Staff Report Memorandum February 5, 2026

To: Planning Commission
From: Community Development Department
Subject: Sequoia Cove Subdivision (Preliminary Review & Special Exception Requests)
1368 E. Coppercreek Rd.
(Community #16, Falcon Park)

SUB11142025-007080
SPX12172025-007095
R-1-8 Zone
1.029 Acres, 5 New Lots

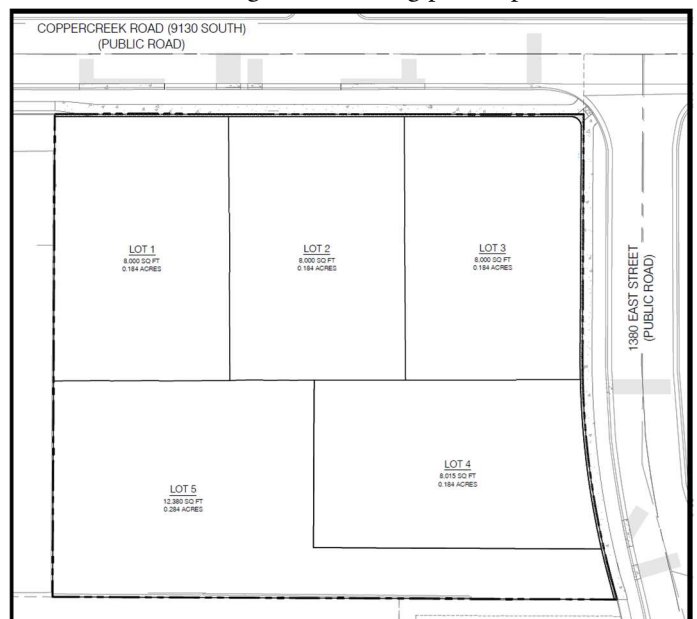
The Silvercrest Park 1 subdivision plat was approved and developed in the early 1970's. The street improvements around this property were installed at that time and conformed to existing code which consists of five (5) foot parkstrips with four (4) foot sidewalks. Sandy City's current standard specifications require a minimum five (5) foot sidewalk width. The developer is proposing to dedicate an additional foot on either street frontage for the eventual widening of these sidewalks. The city Engineer has reviewed this proposal and finds it acceptable based on the precedent established in the neighborhood. This will require a special exception to allow for this deviation (see [section 21-21-10\(n\)](#)).

Staff is concerned about the disposition of the many mature trees within the parkstrips. City code requires that a full tree survey be conducted and reviewed by the City's Urban Forester and Director. The developer will need to provide a plan on how these trees and their root zones will be protected both during and after construction.
